SWIM PROJECT PROFILE		File No. : 136
Regist. No. : Agency No. : BSWM-47	Name: SAN MARCOS SWIP	
Region: 2	Province: QUIRINO	Municipality: CABARRQUIS
Present Status: 1. Pre-F/S() ② F/S(1985) ③ D/D(1985)		
Purpose: Major : Irrigation Incidental : IF, FC, WM		
Project Feature:

SWIM PROJECT PROFILE		File No. : 137
Regist. No. : Agency No. : BSWM-48	Name : SAN FRANCISCO SWIP	
Region : 2	Province : QUIRINO	Municipality : AGLIPAY
Present Status: 1. Pre-F/S() (2) F/S(1985) (3) D/D(1985)		
Purpose: Major : Irrigation Incidental : IF, FC, WM		
Project Feature:

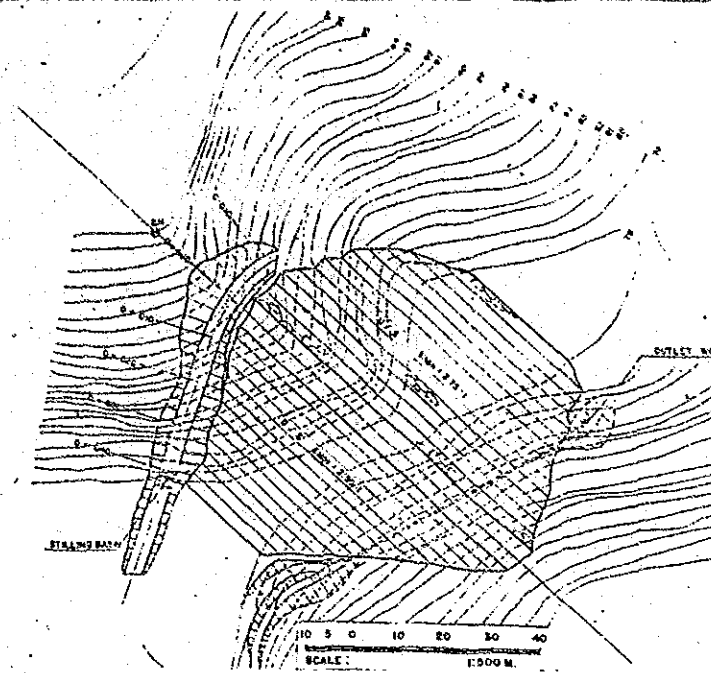
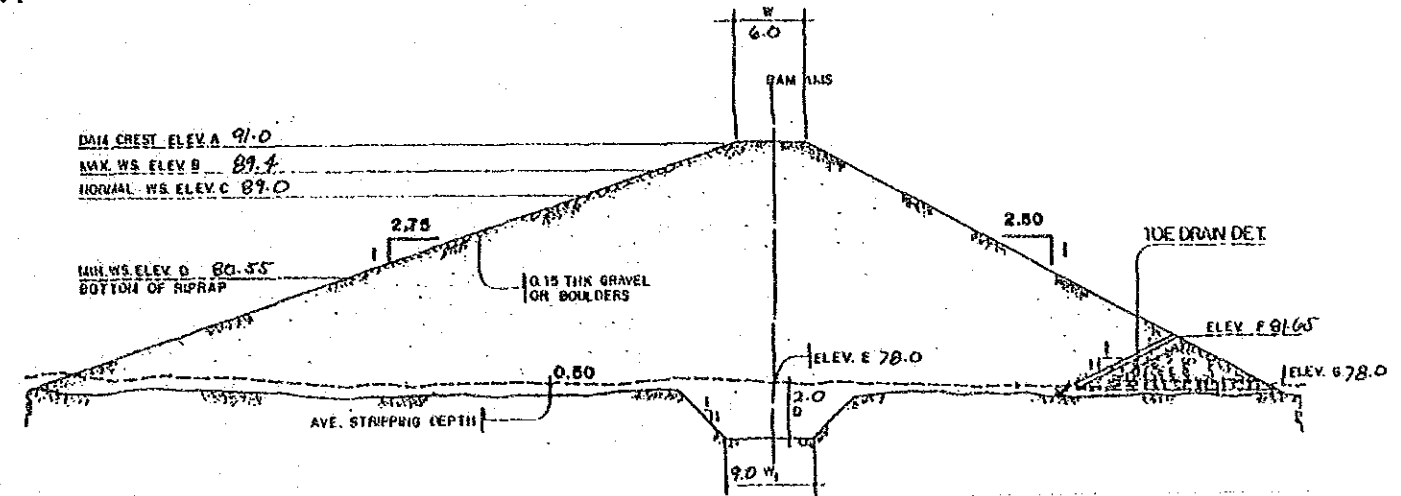
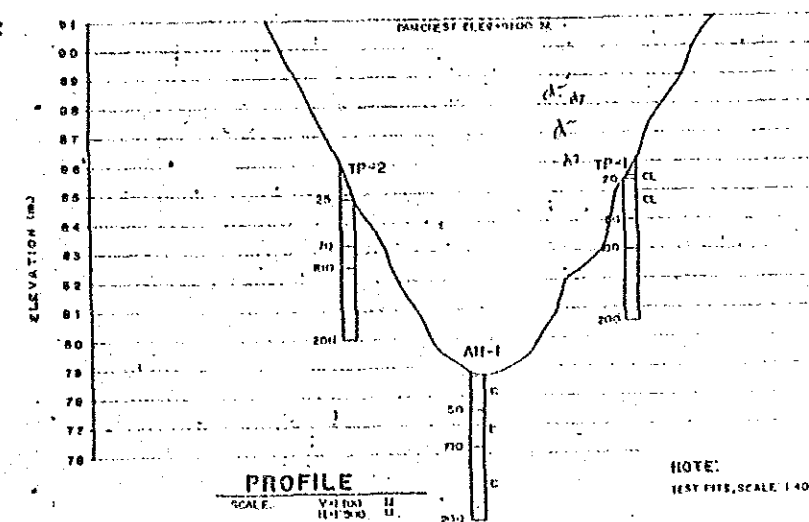
2. Planning Environmental conservation plan is not formulated.		
3. Design Depth of core trench shall be modified during construction. Stability of upstream slope of the dam shall be checked. Freeboard is not enough. Weir shall be provided in the spillway.

Clay with 2.0 m depth is piled up on sand stone, shale and conglomerate. Additional 0.5 m freeboard is necessary.

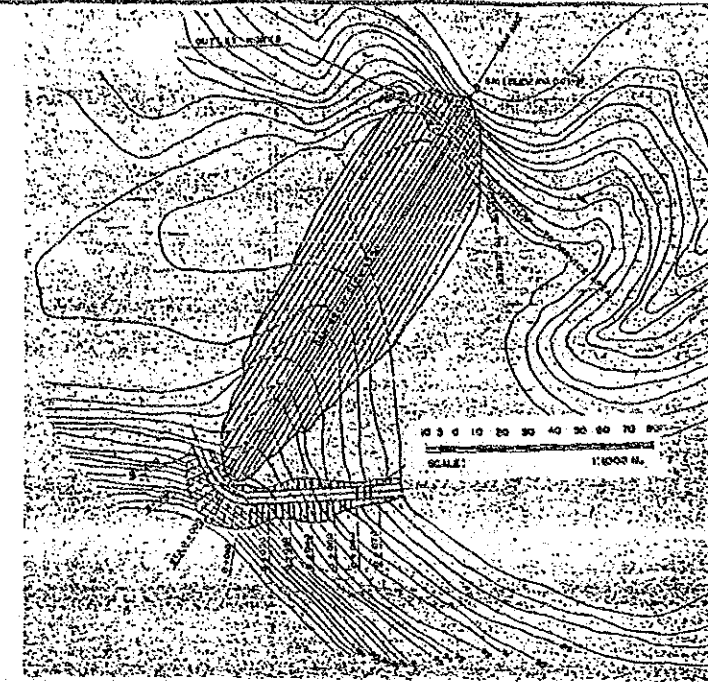
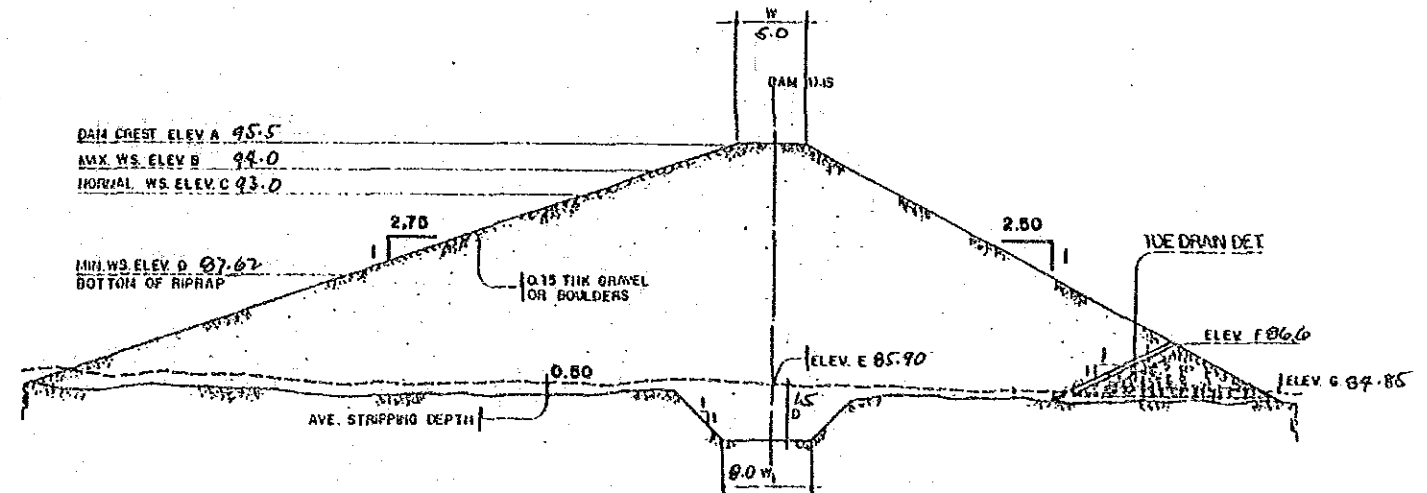
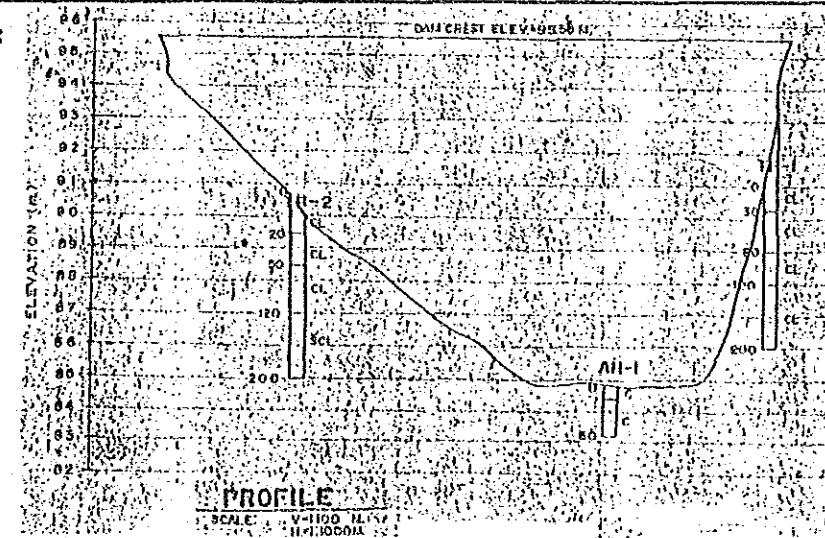
2. Planning		
Environmental conservation plan is not formulated.		
3. Design		
Depth of core trench shall be modified during construction.		
Stability of upstream slope of the dam shall be checked.		
Freeboard is not enough.		
Weir shall be provided in the spillway.

Note: Terrace gravel underlies high weathered sandy clay with 2.0 m depth. Attention have to be paid to the spring water found 200 m upstream. Additional 0.5 m freeboard is necessary.
